DEP-DCP Laboratory
9 Windsor Avenue
Windsor, Connecticut
PROJECT: BI- 2B - 256

ADDENDUM NUMBER 01

May 23, 2011

The following clarifications are applicable to drawings and specifications for the project referenced above.

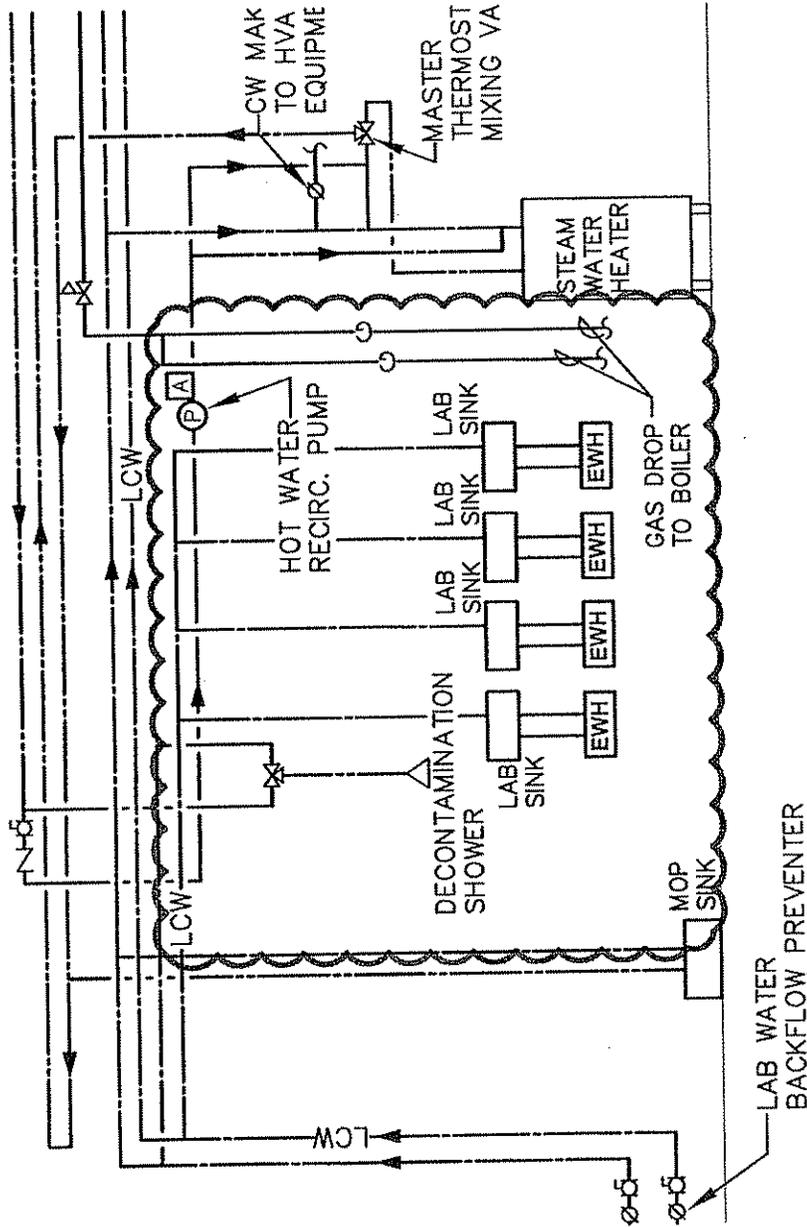
Drawings A2.2 and P1.2 and P3.1

Add: Wall Mounted stainless steel hand sink at south wall, east of the workbench.
Refer to SK-MEP3.4-1, SK-P1.2-1, SK-P3.1-1 and SK-P3.1-2, all dated 05/23/11.
